Application for Works Approval Amendment

Works Approval Number	W5399/2013/1
Works Approval Holder	Murrin Murrin Operations Pty Ltd
ACN	076 717 505
File Number	2013/000523-1
Premises	Murrin Murrin Nickel and Cobalt Project Mining tenements M39/420, M39/421, M39/423, M39/848 and M39/1066 LAVERTON WA 6438 As depicted in Schedule 1.
Date of Report	5 February 2024
Decision	Revised works approval granted

Figure 6: Standing water levels at the 2/3 in-pit TSF, sourced from Minara 2023

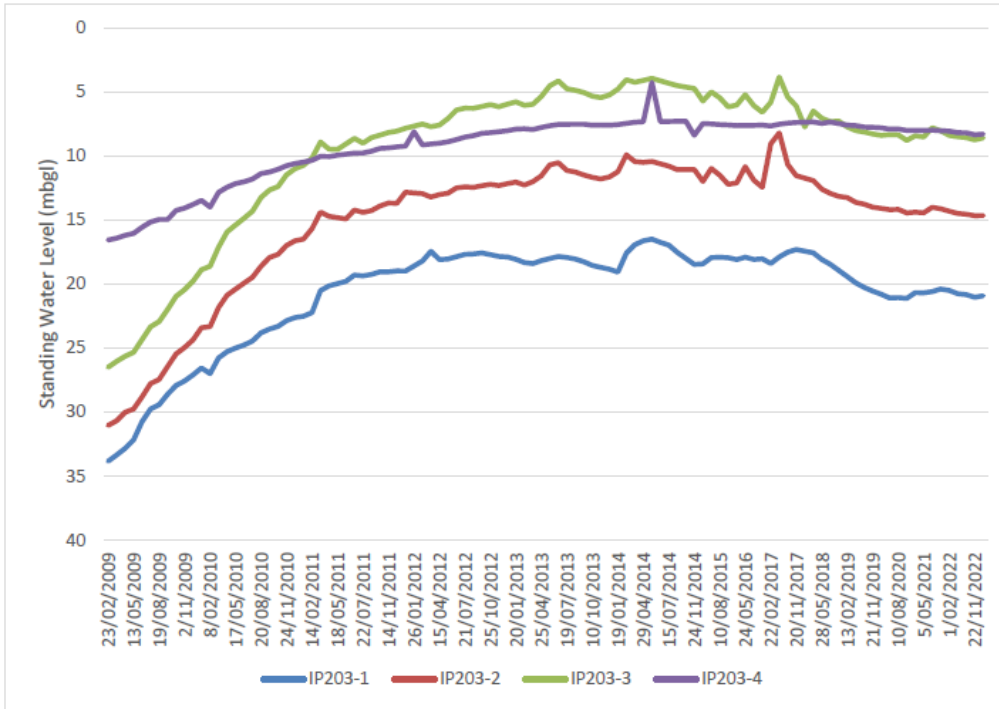
The department considers the consequences of seepage occurring resulting in groundwater mounding in the vicinity of the 19Sth in-pit TSF resulting in scenarios where native vegetation could become impacted as Moderate.

The department determines that the likelihood of the event occurring is Possible as groundwater mounding affecting native vegetation could occur at some time. This likelihood justification has been reached due to other in-pit TSFs in the surrounding area that is operated under Murrin Murrins Licence L7276/1996/12 has shown evidence of increases in SWL post deposition of tailings in in-pit TSFs (Minara 2023) presented in Figure 6 and Figure 7.

The Delegated Officer has considered the consequence and likelihood of this risk event and determined the overall rating is Medium. Based on this rating the risk event is subject to multiple risk regulatory controls listed in Table 3.
